Invincible Southern Extension Project

RESPONSE TO SUBMISSIONS
PART B

Response to Submissions – Part B

Prepared by
Umwelt (Australia) Pty Limited
on behalf of
Castlereagh Coal Pty Limited

Potential storage available and inferred maximum fill level (884 m AHD water level scenario)

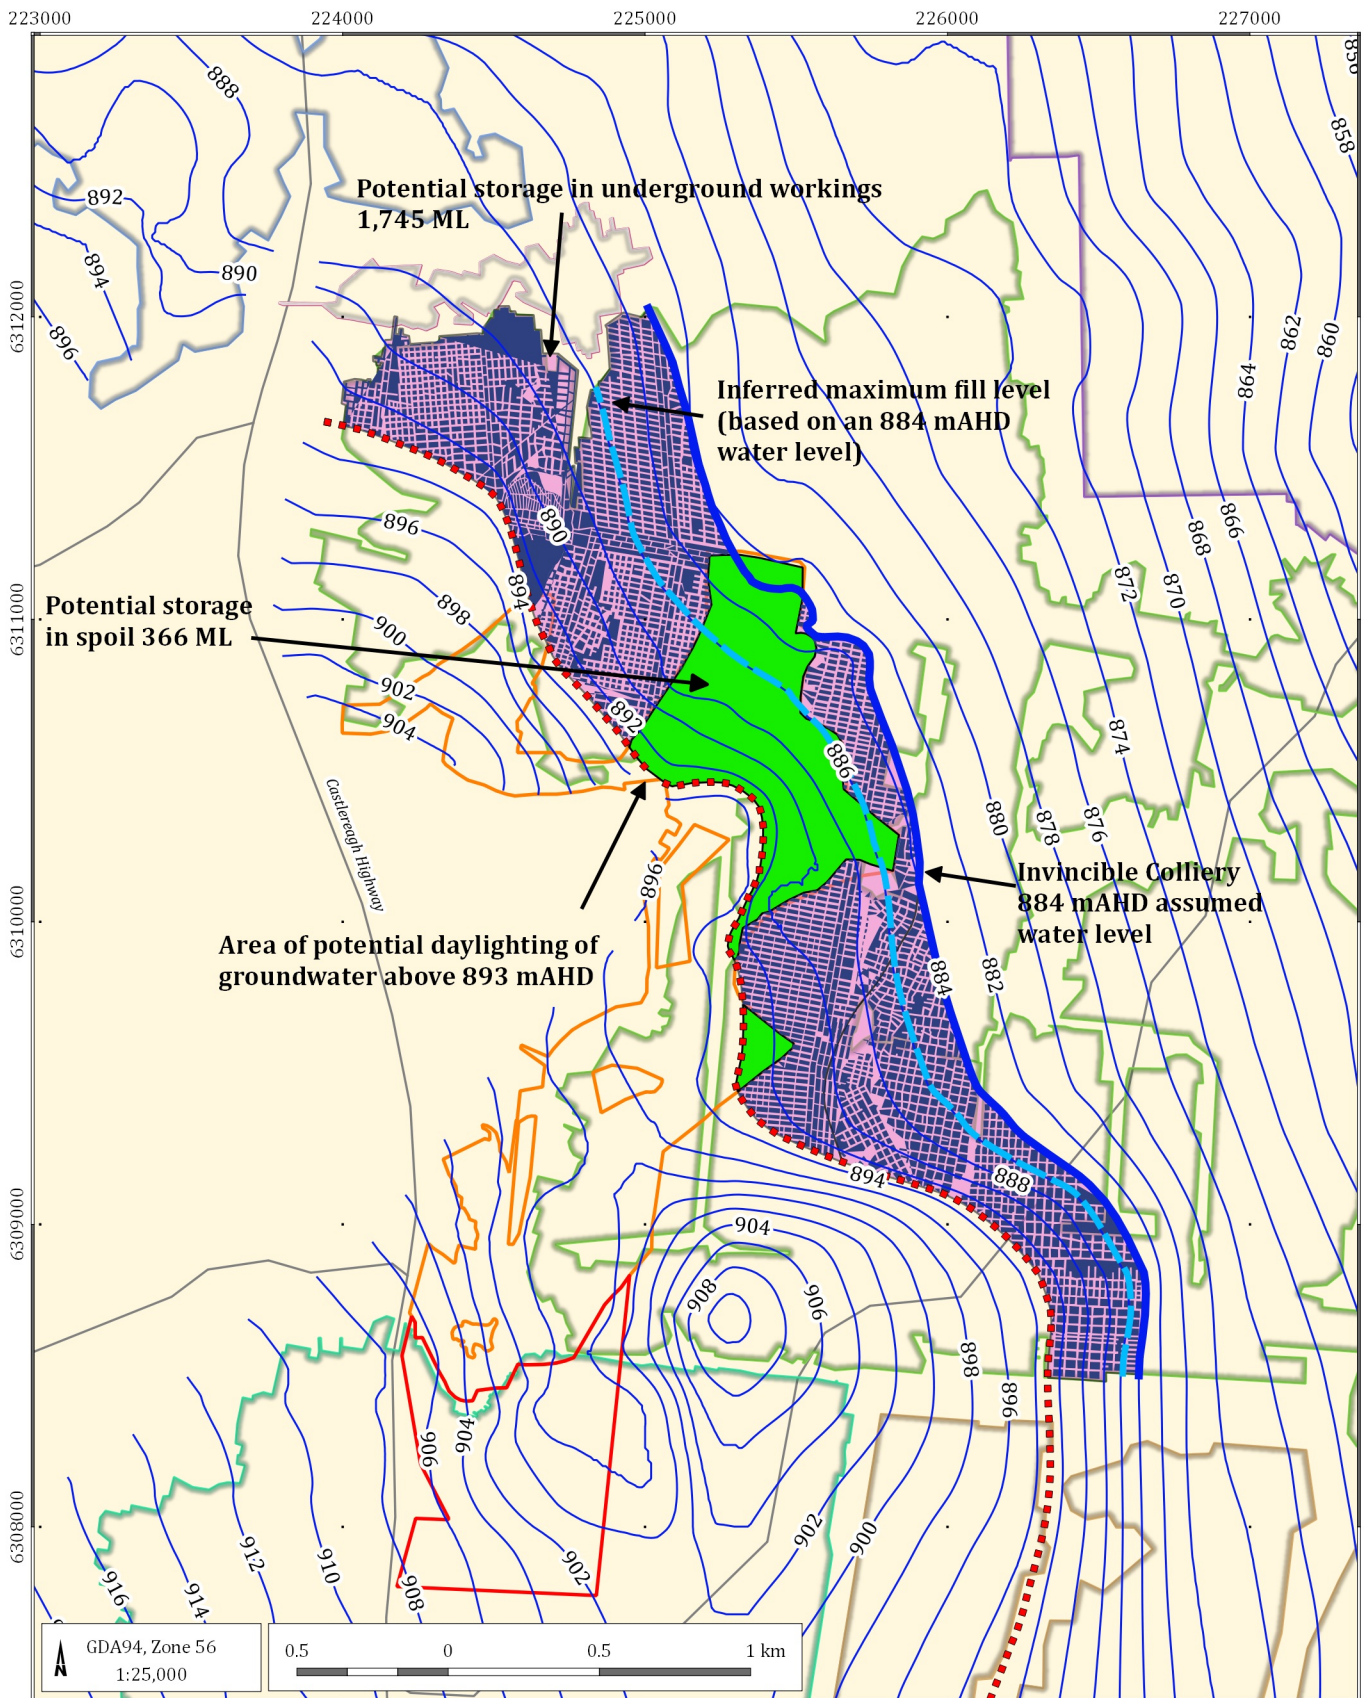
“The proponent should provide further detail of the water balance for the existing Ivanhoe No.2 accumulated water with respect to the 2,121 ML requiring dewatering. It is reported in the EA that the mine void is primarily made up of surface water flow through subsidence fractures, but this is calculated in the EA to be 7-20ML/yr which would total a potential maximum of 200 ML over a 10 year period”.

- AGE (2016) also presented a potential storage area based on a water level in the former Invincible underground of 884 m AHD. This level is correlated to drillhole information from 2012 and follows the coal seam floor contour (at 884 mAHD). A potential storage volume based on a water level at 884 m AHD is in the order of 2,111,000 m³ (2,111 ML); of which 1,745,000 m³ is calculated within the underground and 366,000 m³ calculated within the open-cut spoil (refer Figure 2-3).

- The inferred “maximum fill level” shown on Figure 2-3 is the predicted elevation that the Invincible water level is expected to reach with the transfer of the entire volume of water stored in the former Ivanhoe underground, based on a water level in the Invincible underground workings at 884m AHD. The calculated potential storage volume in the Invincible workings with a water level at 884 m AHD is approximately 5.75 times the volume of water stored in the former Ivanhoe No 2 Colliery underground workings.
